Model: CDX-C910, XR-C900**No.** 415**Subject:** FRONT PANEL FALLS OFF**Date:** March 5, 1997**Symptom:****(213)**

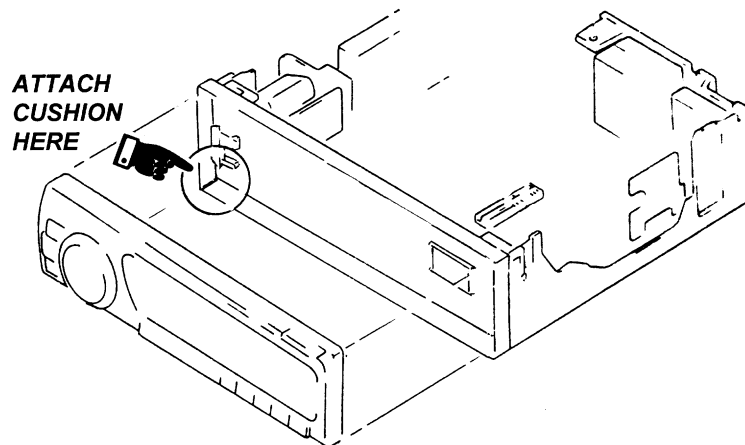
The front panel may fall off from the unit when ejecting . This may happen when the area around the OPEN control button is pressed to hard. This may be caused by the instability of the front panel.

Attach a spacer (cushion) to the left side of the sub panel as shown. The part number is listed in the table below.

REF	DESCRIPTION	PART NUMBER
-	CUSHION	3-938-379-01
